Subject: COOLING UNIT ASSEMBLY LEAKS WATER	Bulletin No: 07-001/02R
	Last Issued: 12/11/2002

All 2001-2002 Millenia

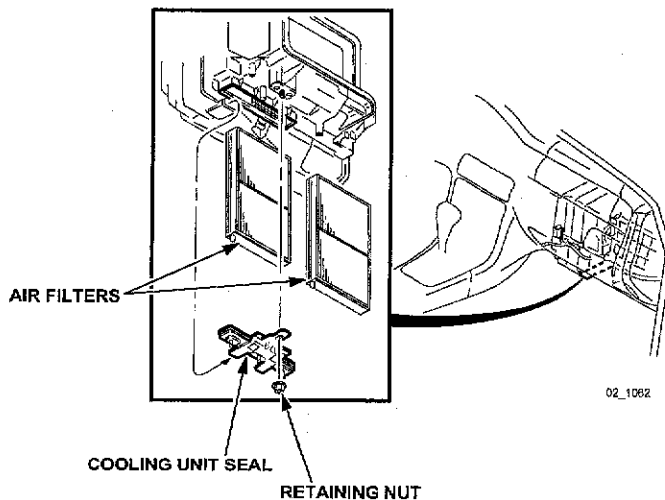
Customer complains of water leaking from under the passenger side dashboard near the footwell area. The possible cause may be due to a deformed rubber seal at the bottom of the cooling unit filter assembly, causing the water to leak at the bottom instead of exiting through the outside drain.

To repair this condition, follow the procedure outlined in this bulletin to replace the rubber seal at the bottom of the cooling unit with a new service part. Do not replace the entire cooling unit assembly.

1. Remove the lower cover under the passenger side dashboard.
2. Remove the retaining nut and the cooling unit seal piece, which covers the air filter access slot.

3. Position a new cooling unit seal into place and tighten the retaining nut to 9-13 in.lbs. (1.0-1.5 N.m)
